### **m e m o r a n d u m**

**FROM:** Marcus Ricci, Planner II

**DATE:** April 7, 2017

**SUBJECT:** **2017-LBDRB-01:** A request by Chris Saunders, Vision Housing, LLC, for design review of a residential development at 802, 804, and 806 South Lincoln Avenue and 809 West Nevada Street.

**A1.G**  
SITE PLAN + GROUND FLOOR PLAN  
SCALE: 1" = 10'-0"  
0 10 20

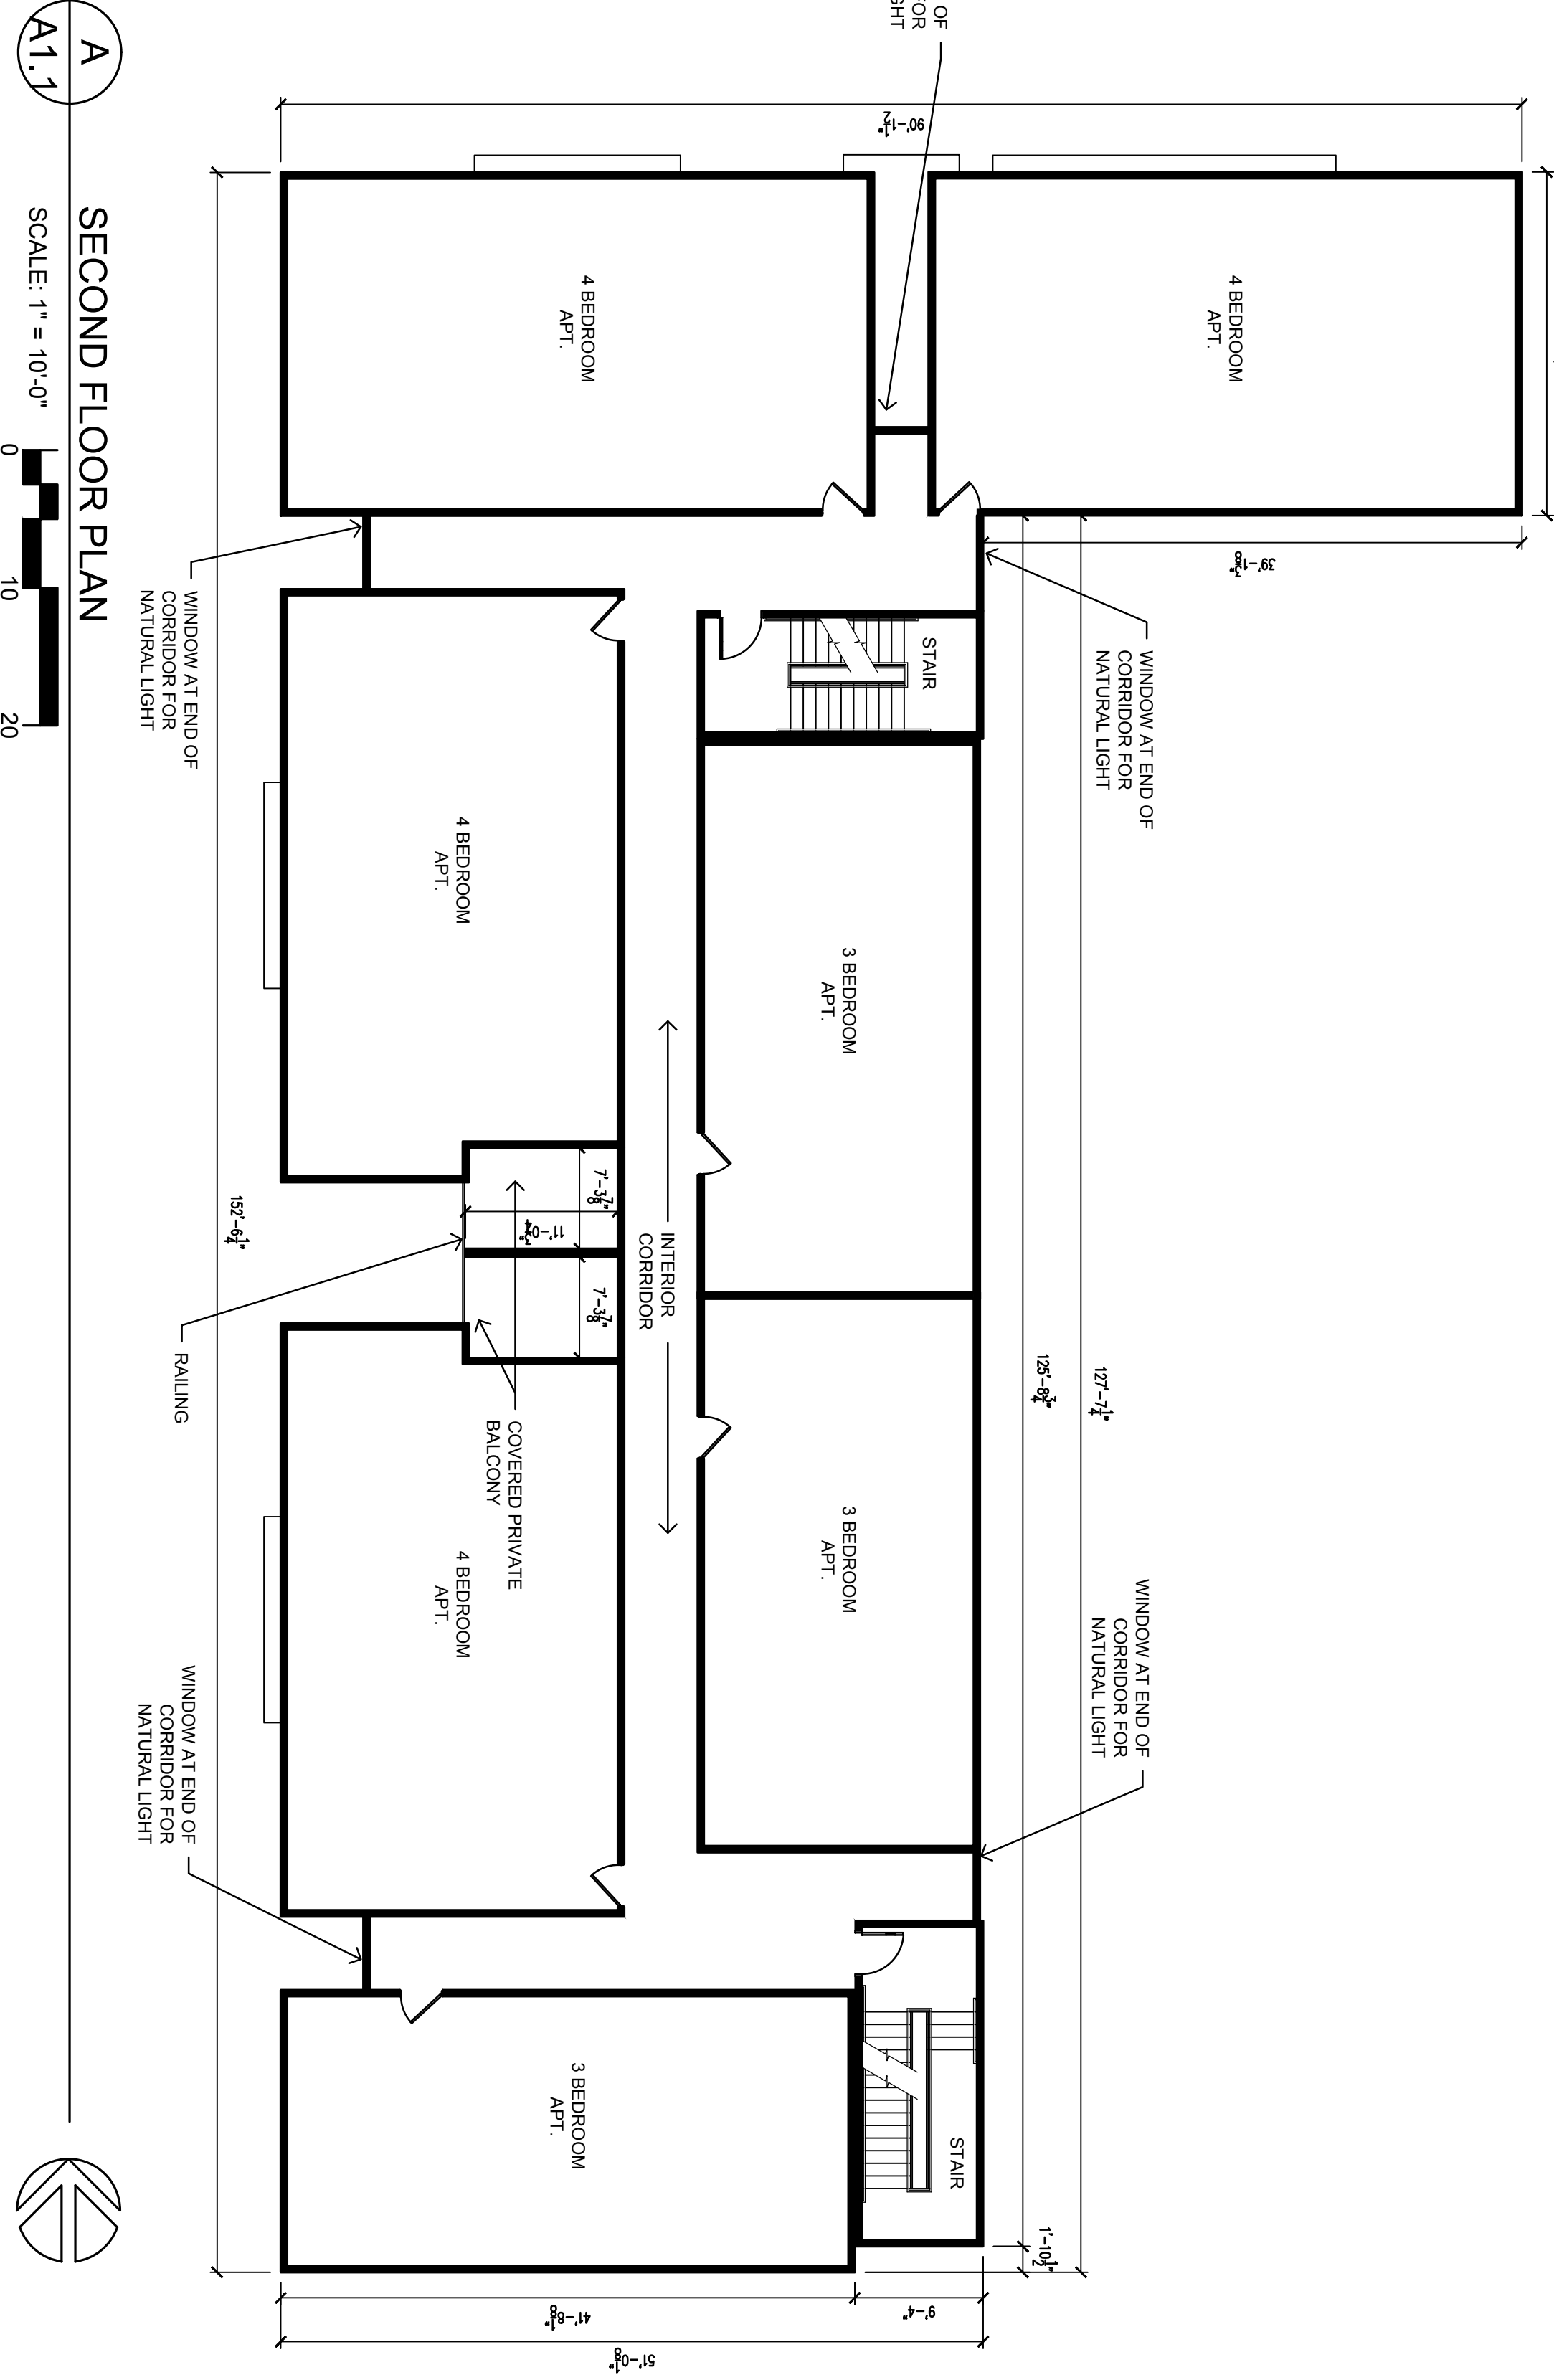
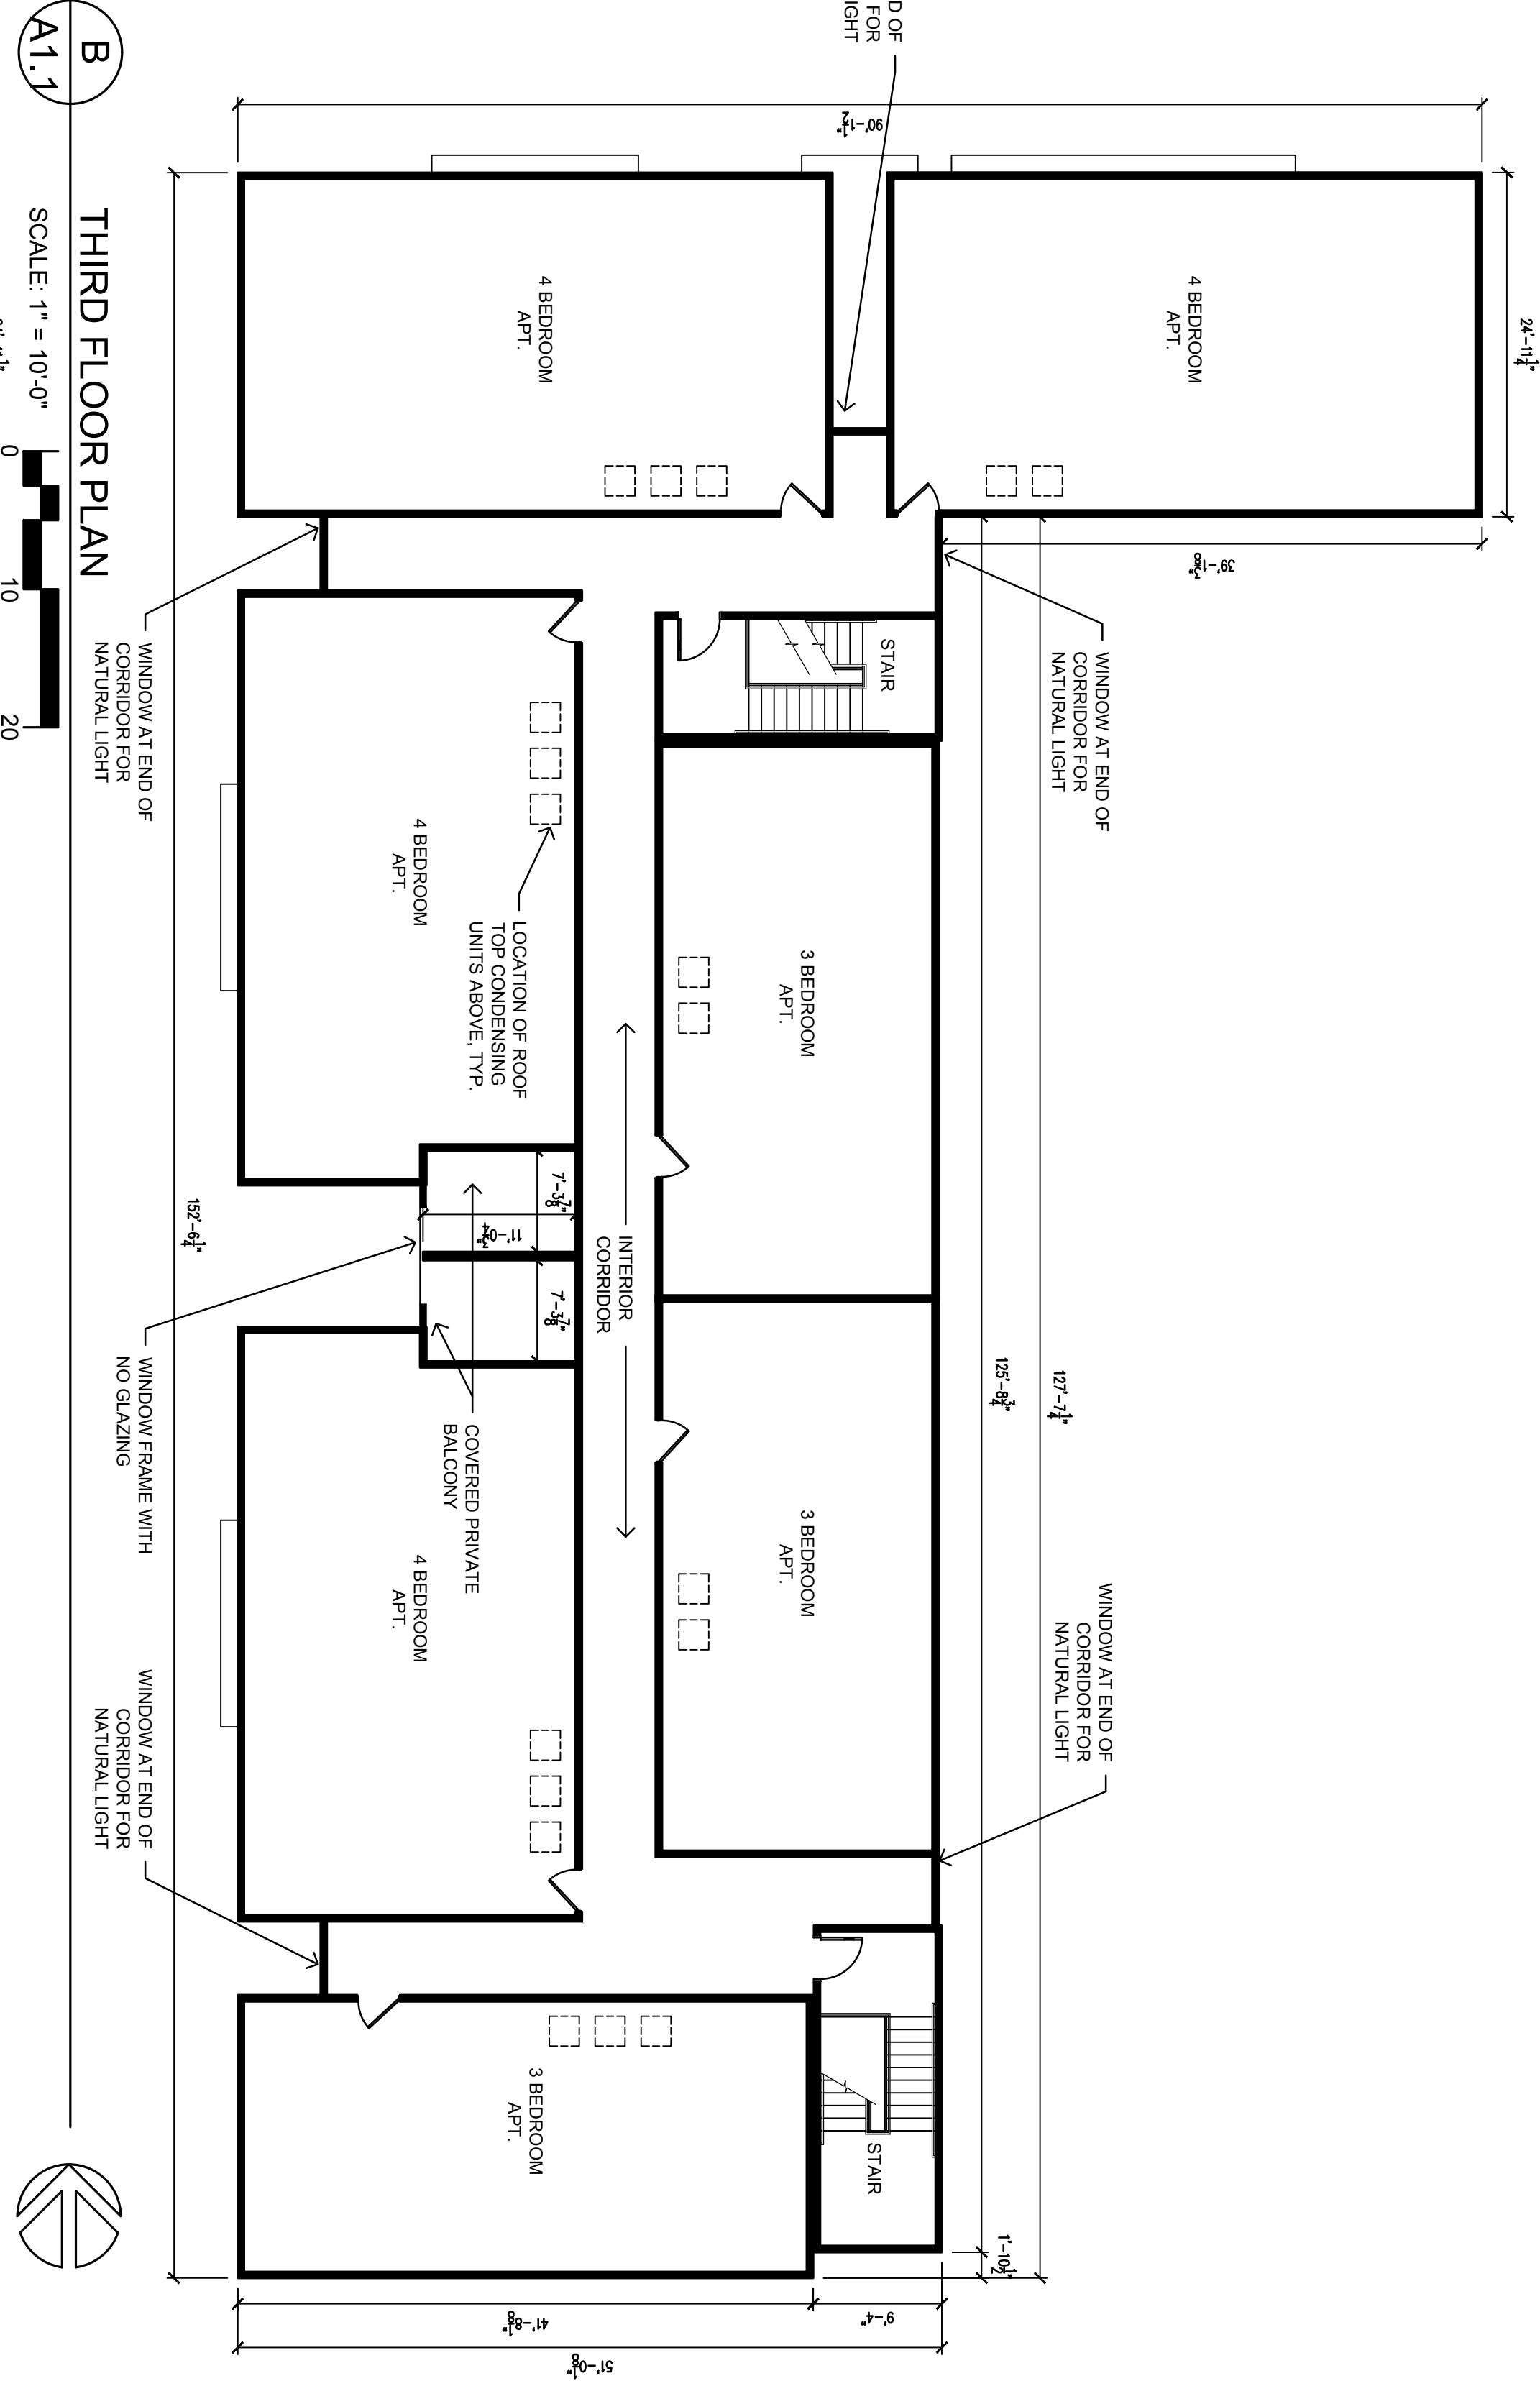
and West Nevada Street (Exhibit C, Sheet A1.G.). The primary entrance is located on West Nevada Street, secondary entrances are located on South Lincoln Avenue, and additional entrances are located on the south and east building faces.

- The mature pin oak tree at the Lincoln-Nevada corner of the proposed developments will be preserved (Exhibit C, Sheet A1.G).
- Three shade trees will be planted around the parking lot; some may serve as shade for outdoor living spaces.
- Building faces and portions of the fence line will be enhanced with a variety of shrubs and herbaceous species, while maintaining safe pedestrian and automobile traffic circulation on and off private property.
